Waste Licence Review Application W0167-02

Response to Article 13 Compliance

December 2009

Appendix 13.a: Revised Water Balance (Figure D.1.c of RWLA)

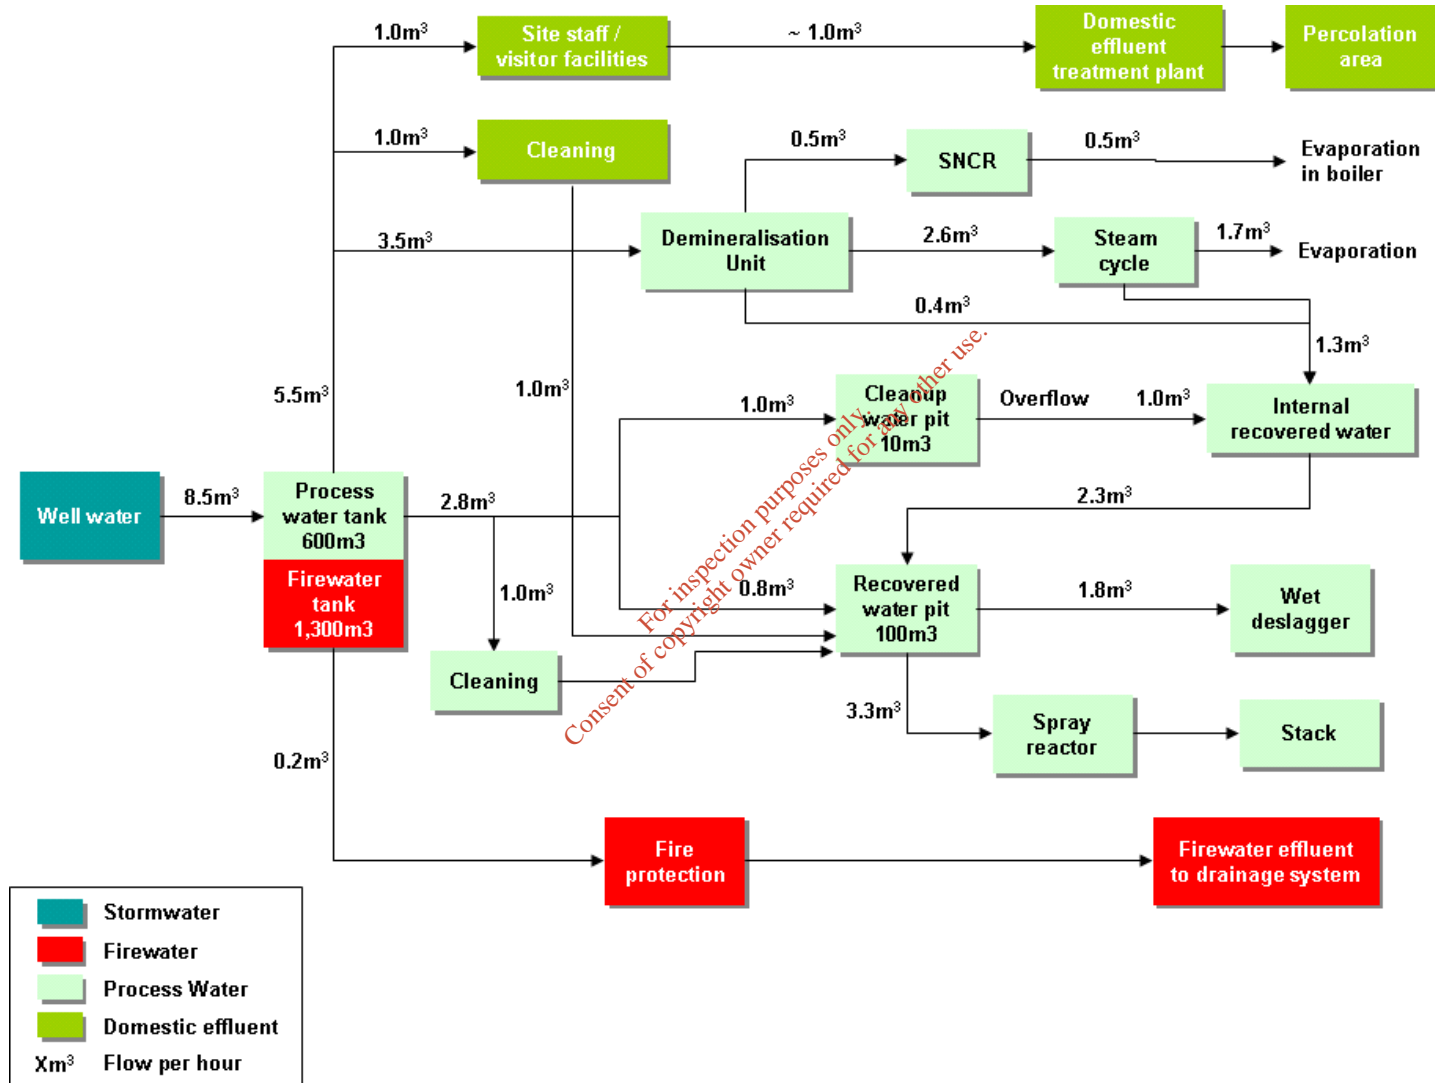
A revised water balance is provided in Appendix 13.a.

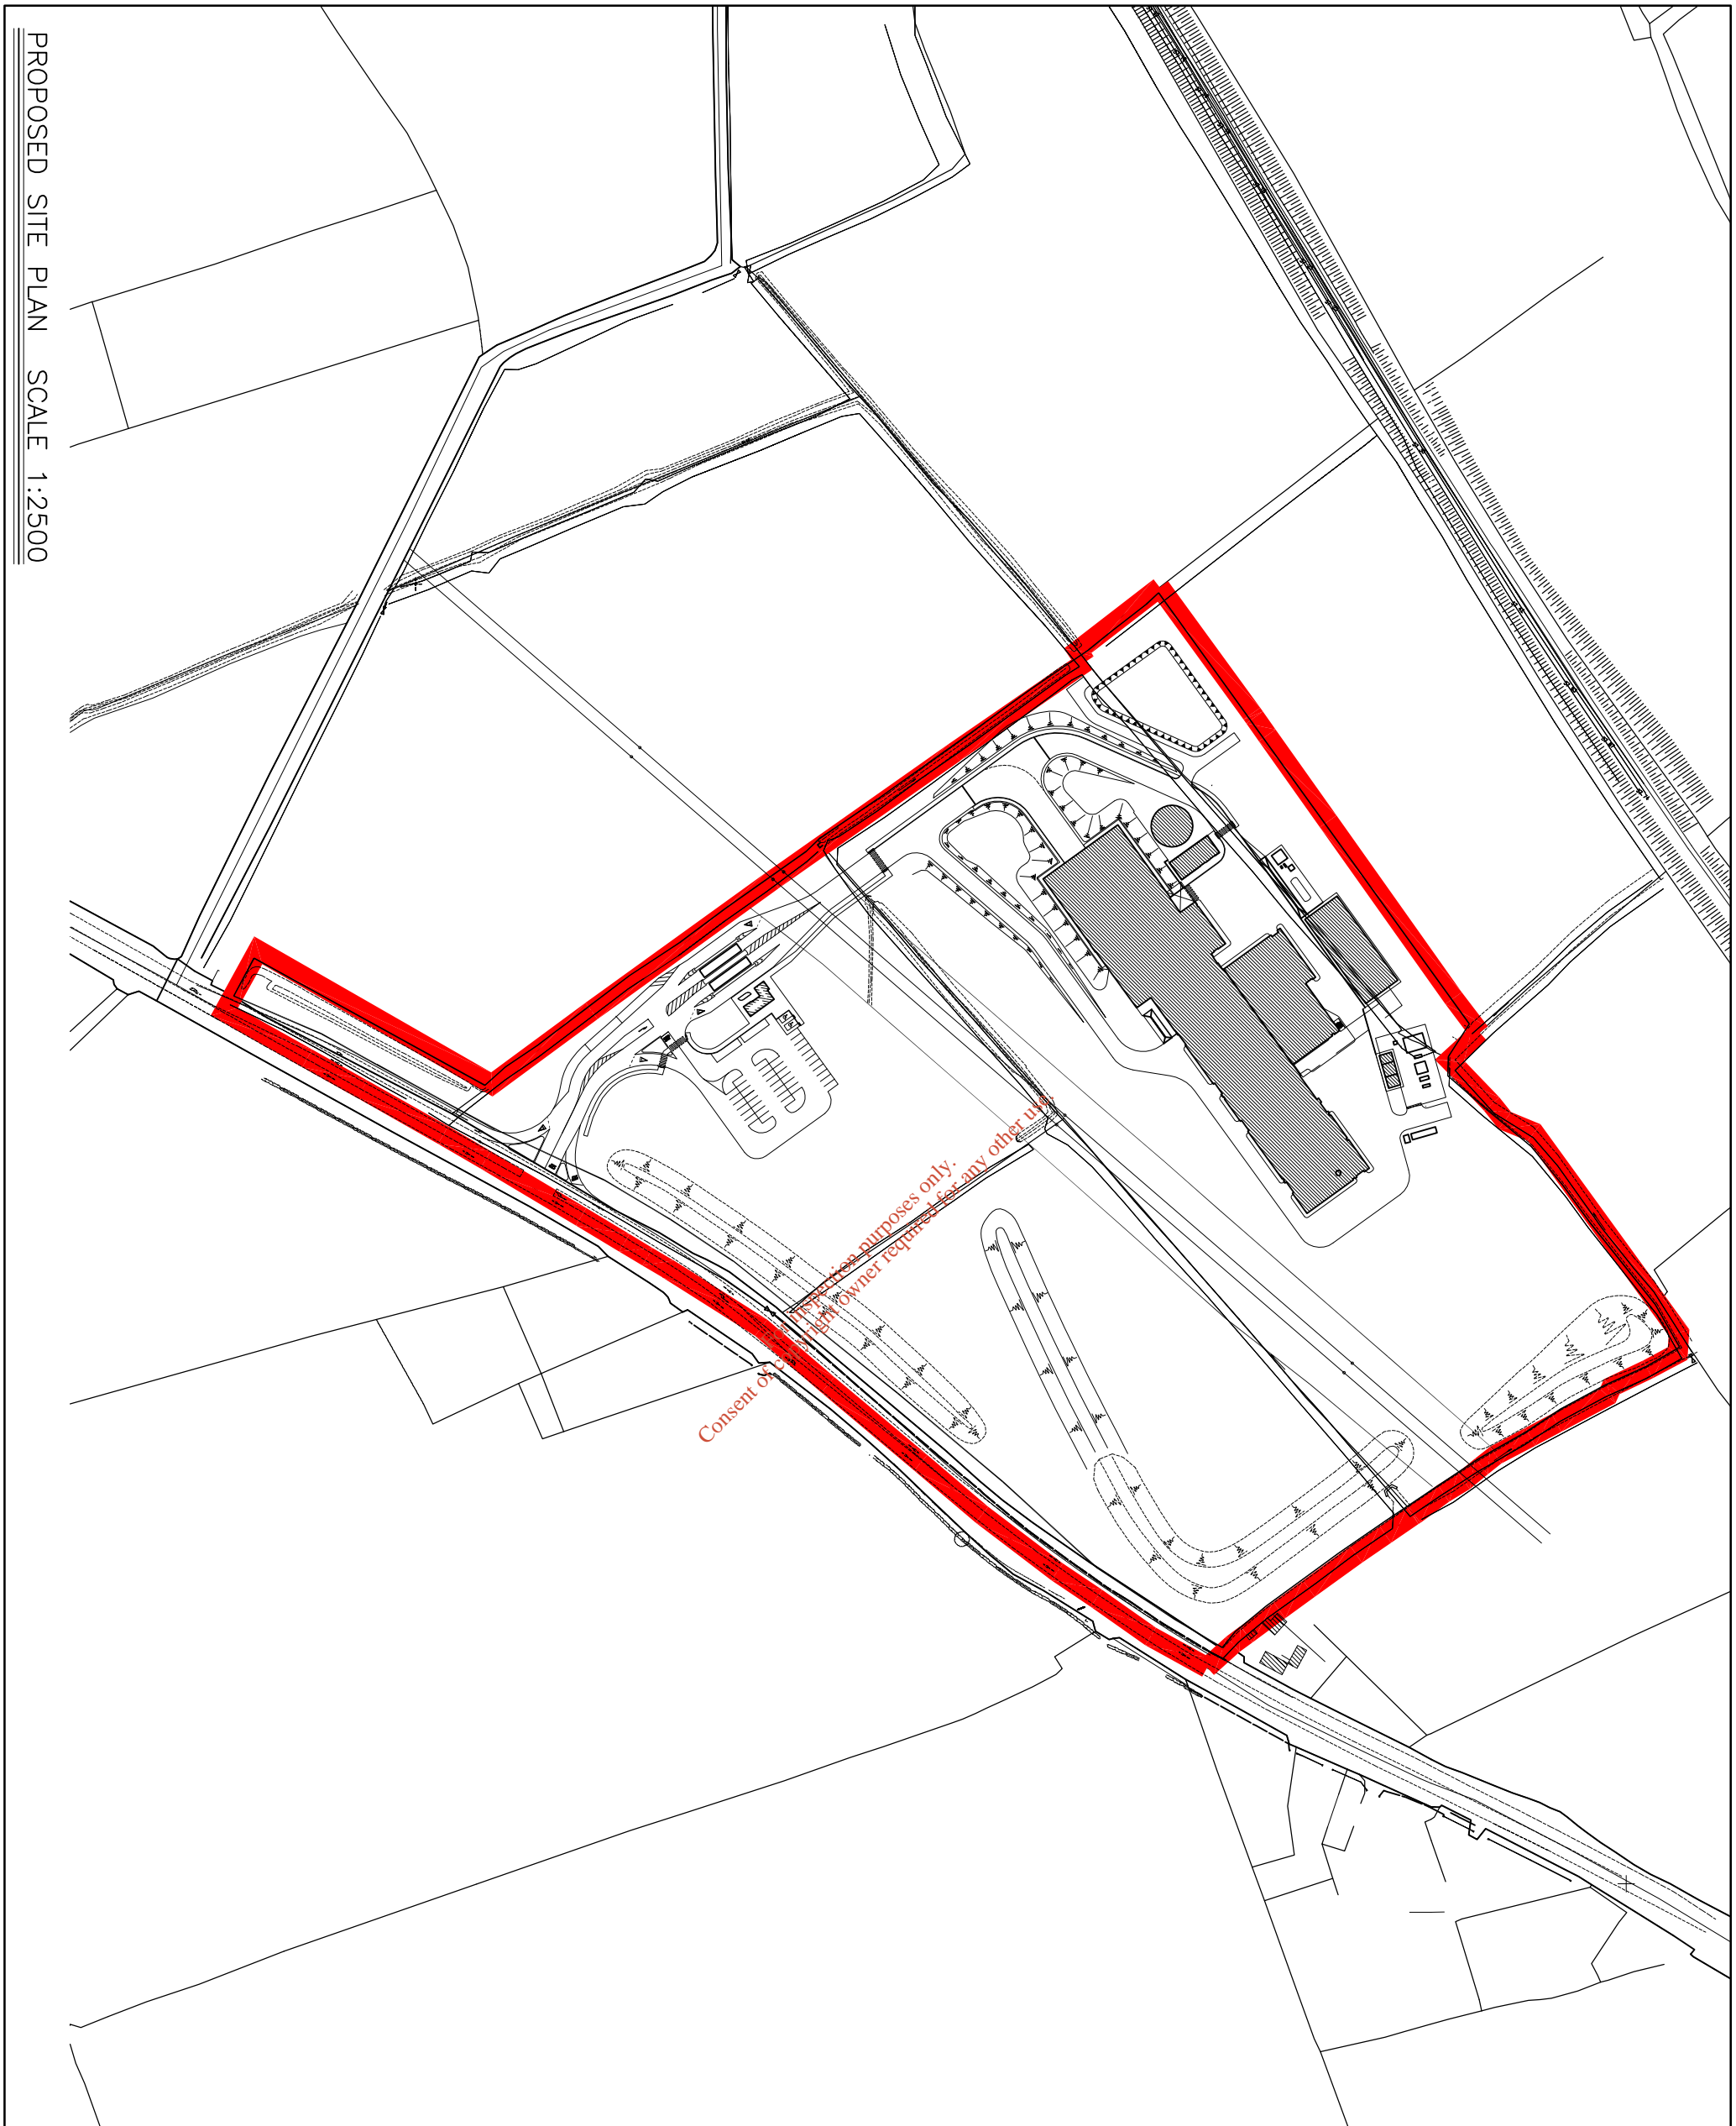
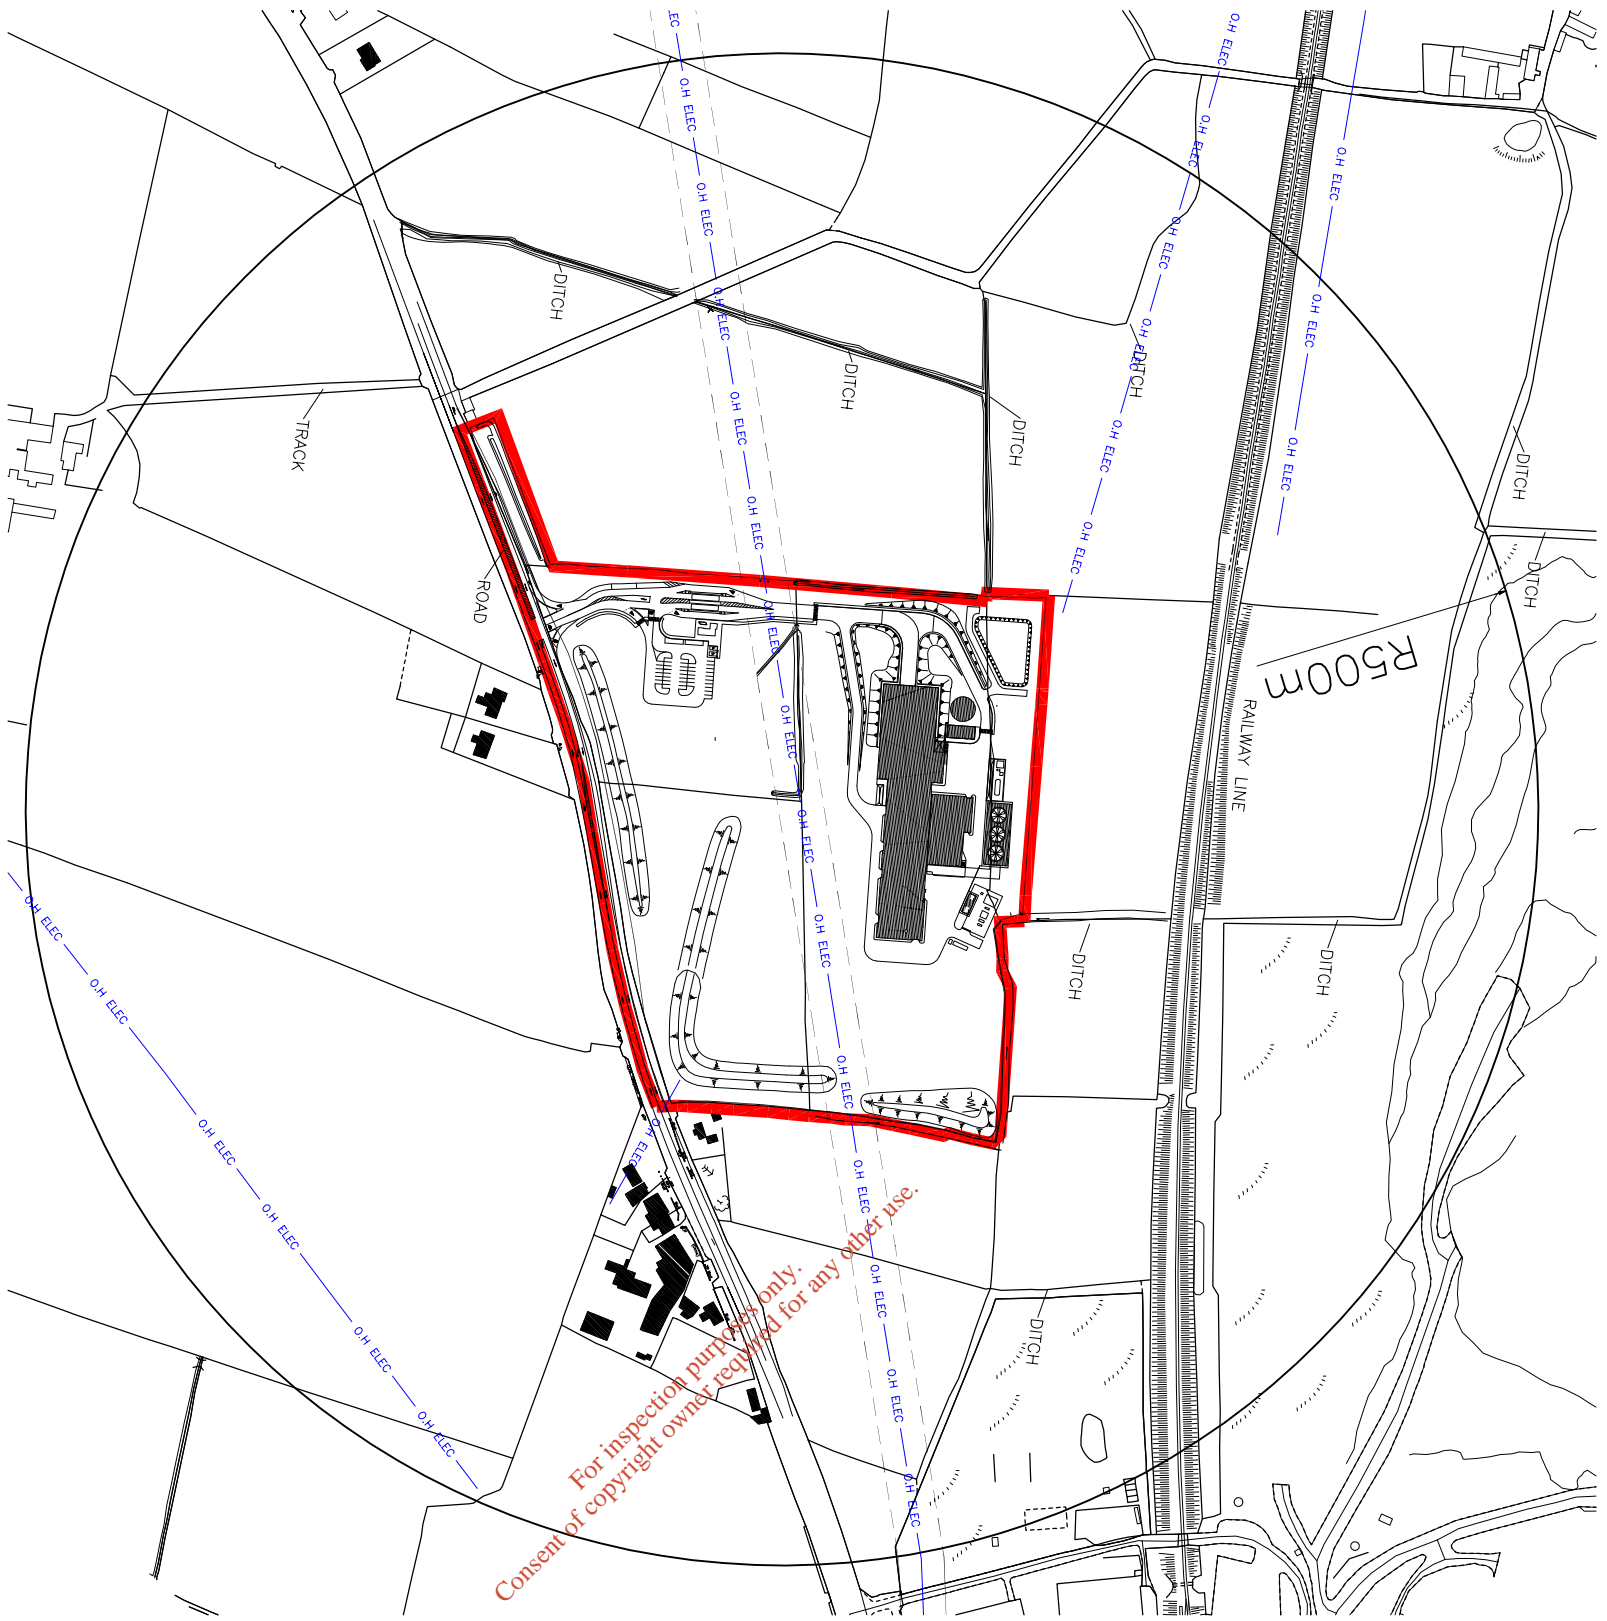
Drawing	Modifications
Appendix B2: Site Ownership Plan	There are no changes to the Site Ownership Plan
Appendix B3: Site Plan	The site boundaries of the activity have not changed. However, the Site Plan drawing 15013\WL\002 in the RWLA shows the previous facility layout which has now changed. For completeness, a revised Site Plan drawing 18081\WL\002 is provided in Appendix 13.b.
Appendix B4: Location Map	The location of the facility and the surrounding details has not changed. However, as for the Site Plan drawing above, drawing 15013\WL\003 in the RWLA shows the previous facility layout which has now changed. For completeness, a revised Location Map 18081\WL\003 is provided in Appendix 13.b.
Appendix B5: Services Plan	The location and nature of underground services has not changed. However, drawing 15013\WL\004 in the RLWA shows the previous facility layout which has now changed. For completeness, a revised Services Plan 18081\WL\004 is provided in Appendix 13.b
